UNITED STATES PATENT AND TRADEMARK OFFICE

APPLICATION NO.	FILING DATE	FIRST NAMED INVENTOR	ATTORNEY DOCKET NO.	CONFIRMATION NO.
10/807,336	03/24/2004	William A. Peterson JR.	051252-5050-03	3493

Office Action Summary	Application No. 10/807,336	Applicant(s) PETERSON, WILLIAM A.	
	Examiner Trevor E. McGraw	Art Unit 3752

DETAILED ACTION

First Figure

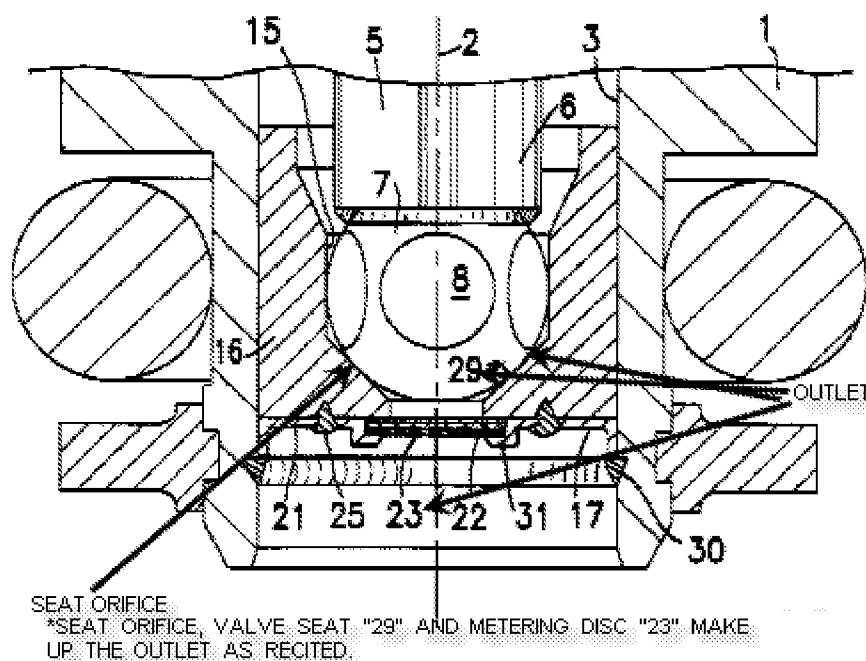
channel surface ((see curved surface of "35" that serves at the first channel surface in Figures 21 and 22 where the first surface of the flow channel between "36" and "38") so as to provide a flow channel (channel between "36" and "38") that is separate from but in communication with the seat orifice (see "seat orifice" in the first figure provided below), the metering disc (23) having a plurality of metering orifices (38) extending therethrough along the longitudinal axis (2) and located about the longitudinal axis (2), the metering orifices (38) being in communication with the flow channel , locating all of the metering orifices (38) on a first virtual circle (see Figure 31 where "38" is shown on a virtual circle) outside of a second virtual circle formed by a virtual extension of a sealing surface of the seat (seat as shown in Figure 1) on the metering disc such that each of the metering orifices extends generally parallel to the longitudinal axis through the metering disc and imparting a radial velocity to the fuel flowing from the seat orifice through the flow channel (channel between "36" and "38") so that fuel flows in transverse direction across and through the fuel metering orifices (38; see where flow travels transverse and out of "38" in Figures 4-8 and 10).

Applicant's arguments filed 09/29/2009 have been fully considered but they are not persuasive. Examiner cannot agree with Applicant's assertions stated on pages 8-9. Examiner notes that Ardnt et al does denote a flow channel and clearly shows where the fuel injector has a valve seat with an orifice and a first channel surface that extends obliquely to the longitudinal axis. Examiner has shown in the first and second figures above the location of the features that Applicant has said on the record that Ardnt et al lacks. Ardnt et al as shown in the figures provided clearly teaches having an orifice, valve seat and first channel surface that is orthogonal to the longitudinal axis as

required by Claim 23. As a result, Examiner maintains the rejection against Claims 23-27.
